Optimized Power Coupling Inductance Day 2

Adjustments after 1st day of conference

Text Modification to allow variable L_{pod}

Unit Load Adjustable Limits

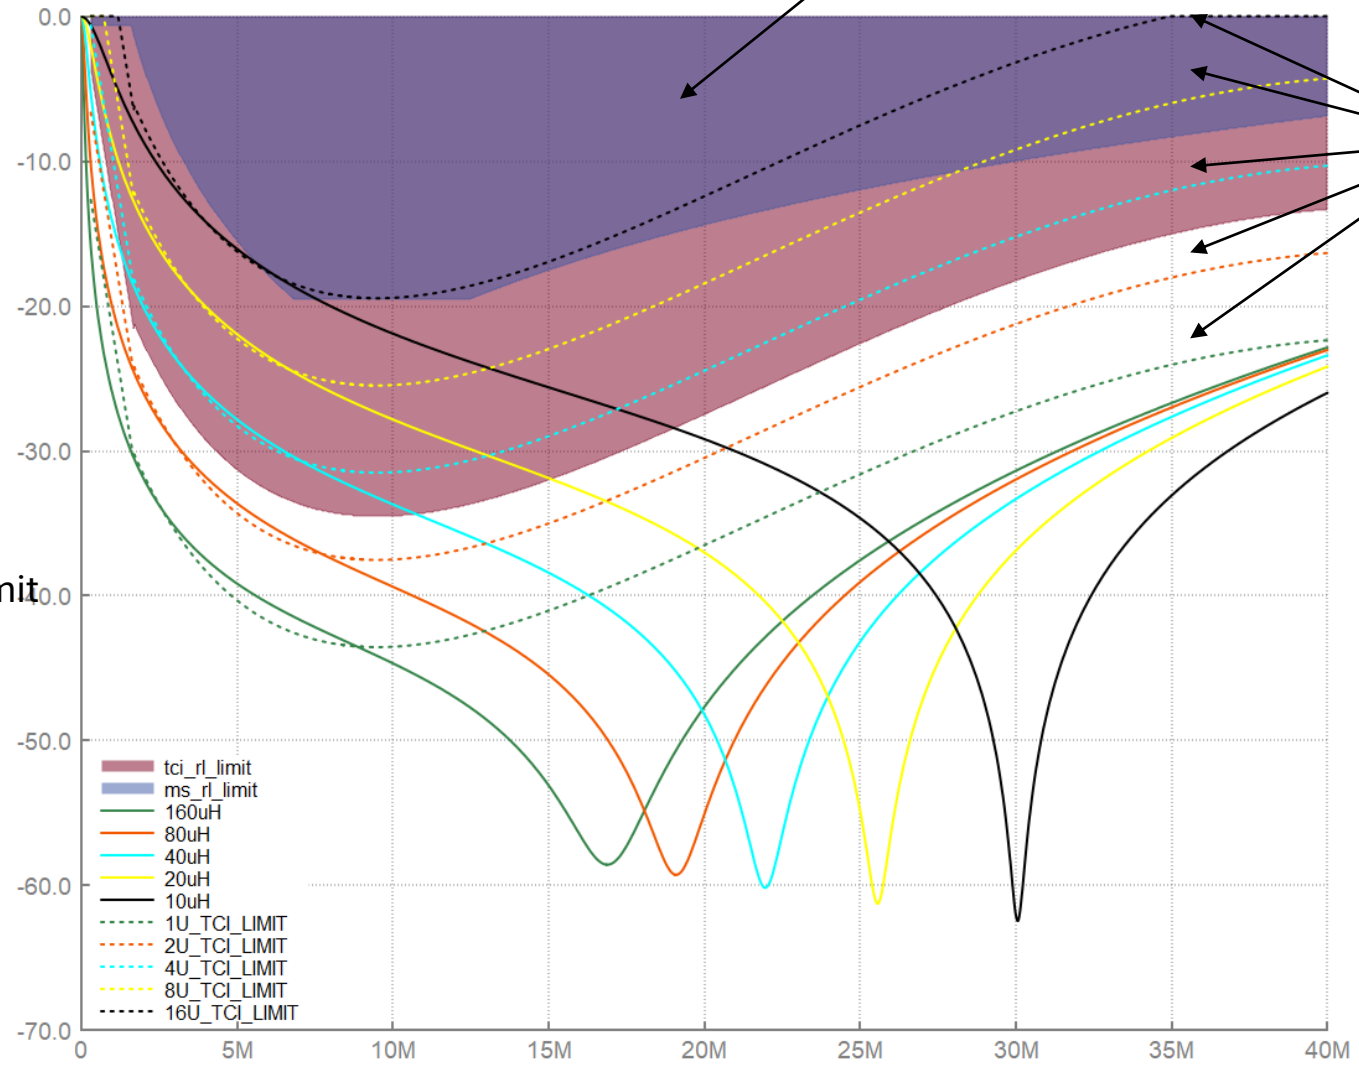
GZ Proposed Adjustable Limits

Equation (188-7) ...
 plus $10 \cdot \log_{10}(N_{load})$,

TCI_RL Limit lines
After unit load
adjustment

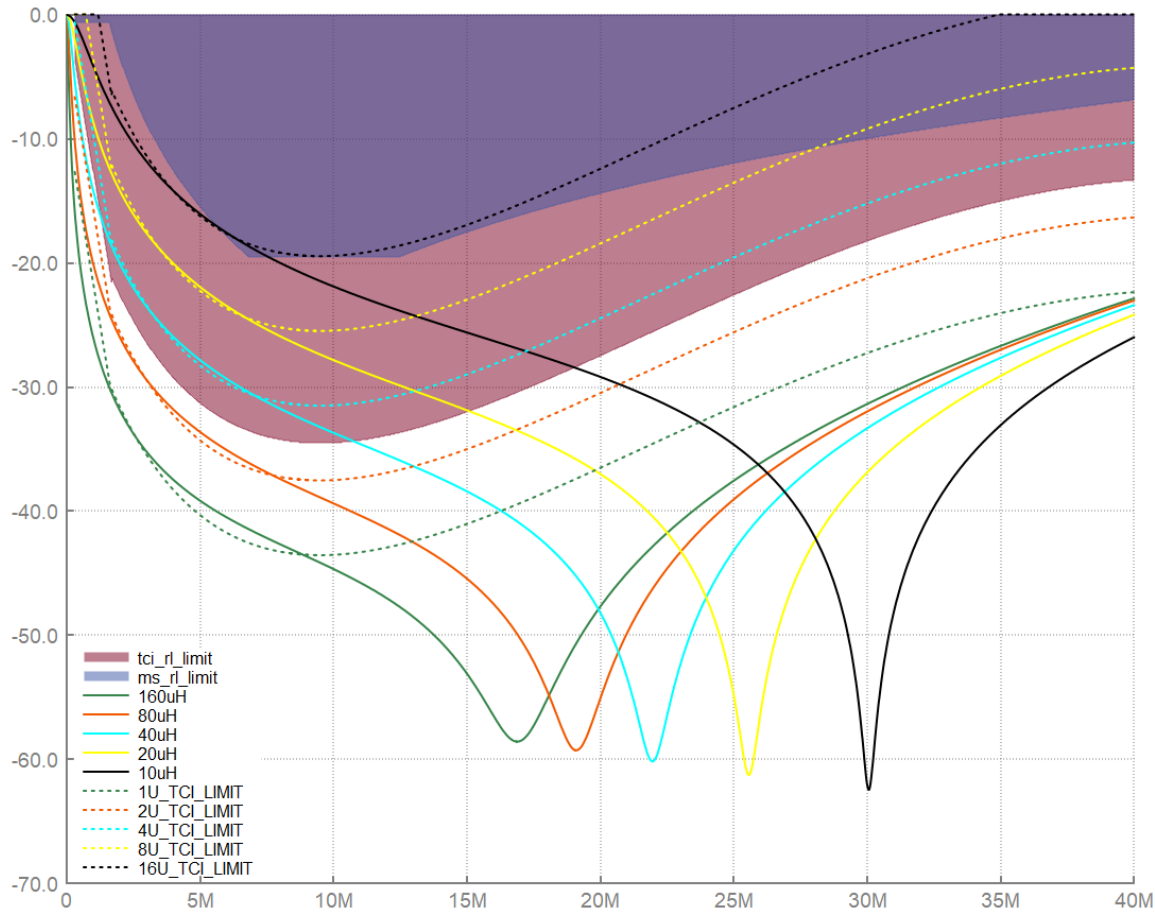
Stephan Schriener's new proposed RL Limit

Equation (188-7) ... plus
 $10 \cdot \log_{10}(N_{load}^2 / 8)$,

Lines fit better, but 1U device limit
Dropped by ~10dB

Comparing linear and log X scales

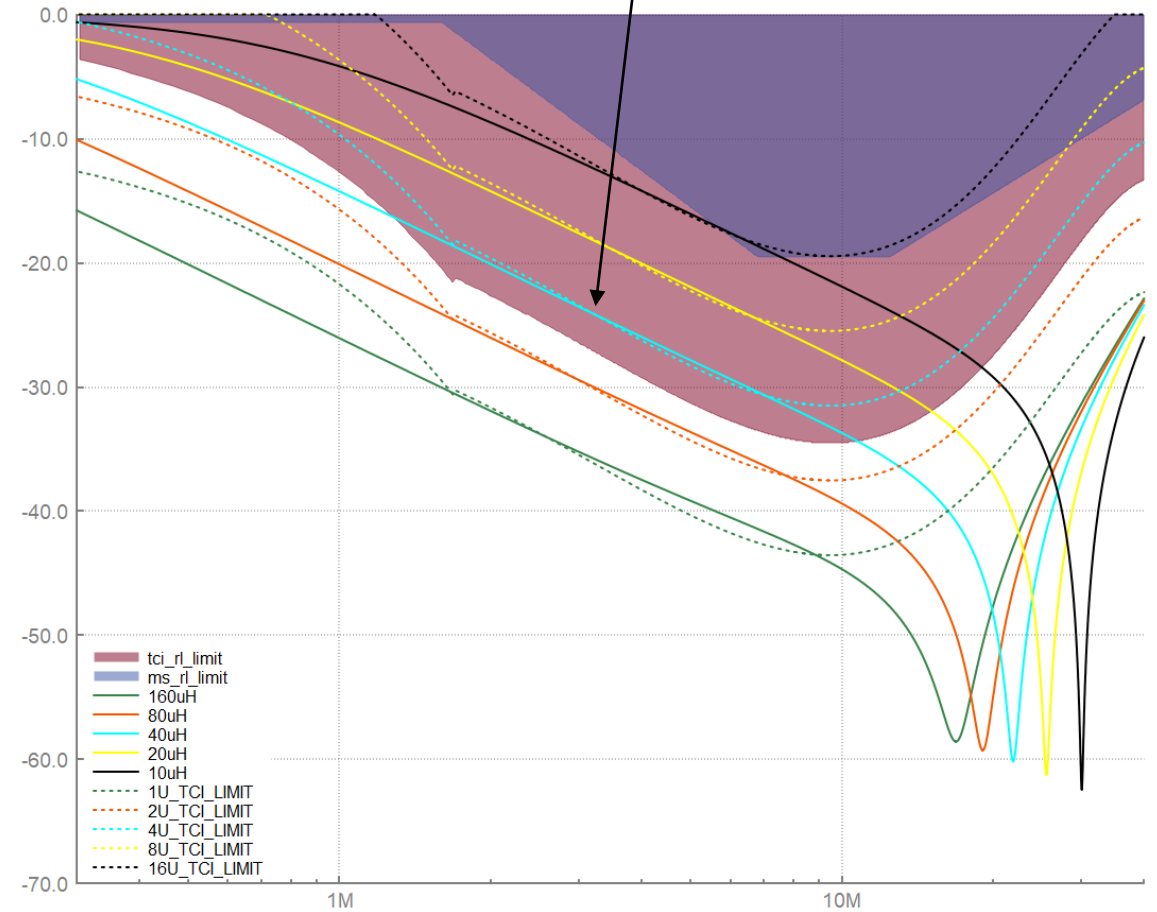
Inductors have -20dB / decade characteristic

Todo:
Analyze how to move the low frequency line without affecting the high frequency RL
Comment against D2.1 with update

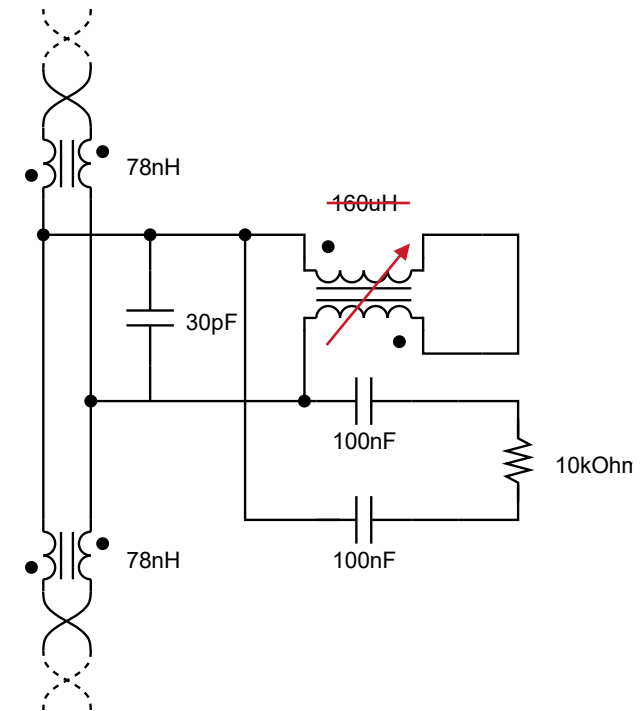
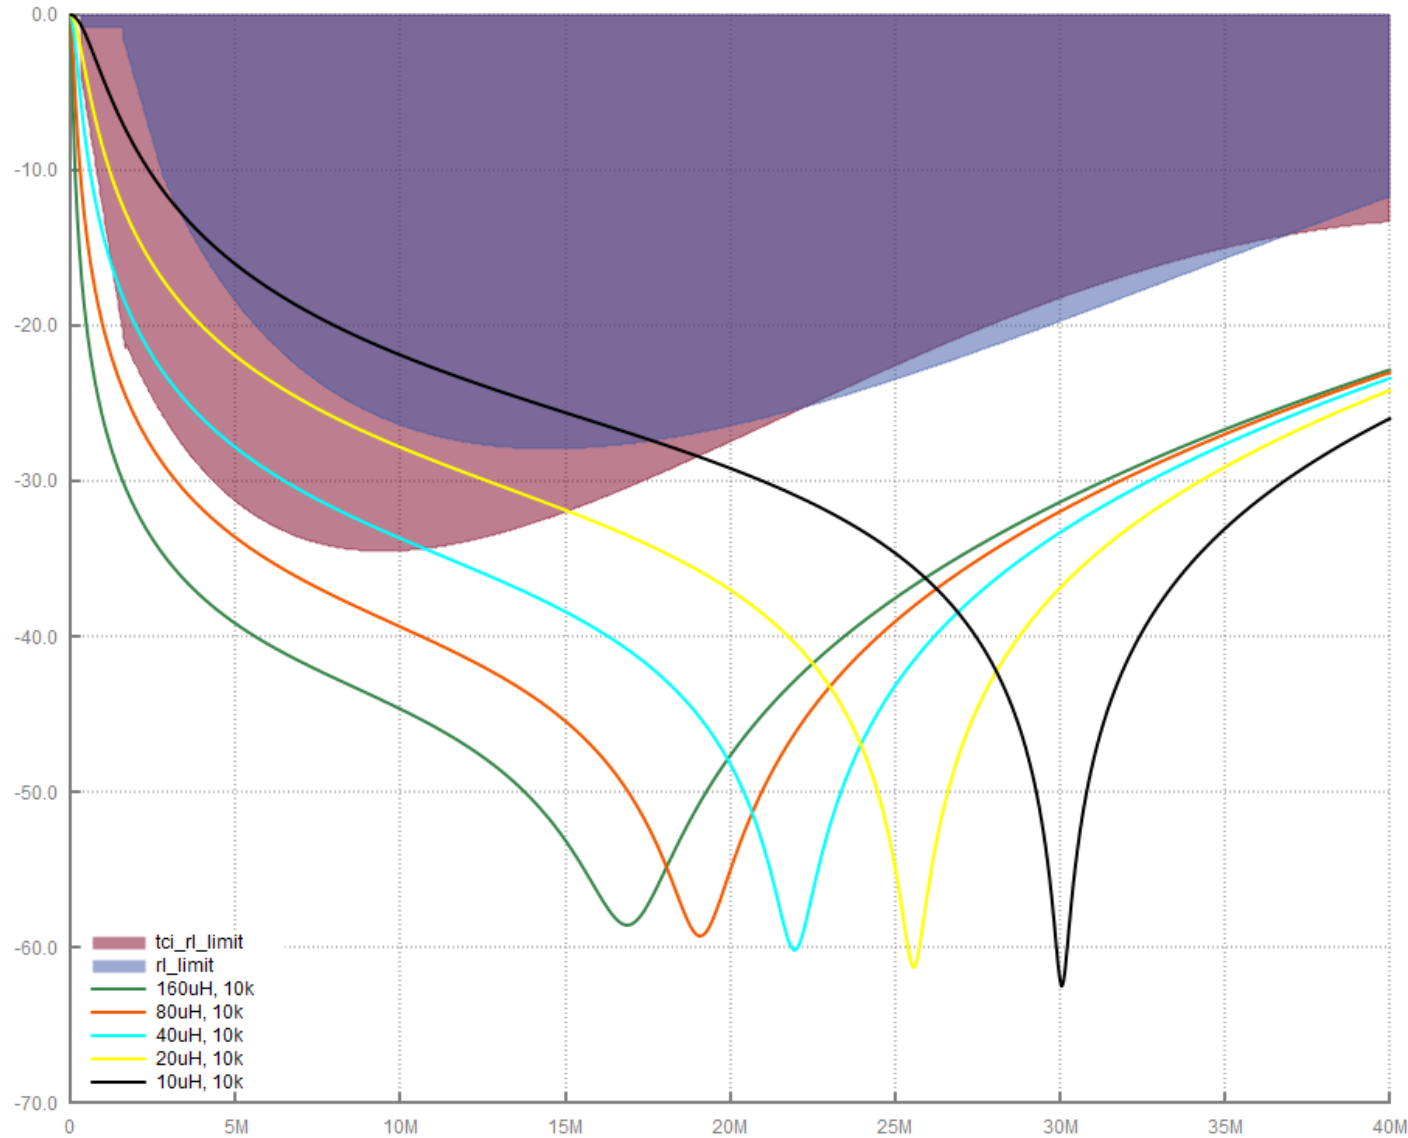
In 802.3da Draft 2.0, the power coupling inductance is limited by the TCI Return Loss limit specified in clause 188

The TCI return loss limit is calculated for nodes with ~80uH power coupling inductance

We need it to accommodate ~10uH for 16U devices and 160U for 1U devices
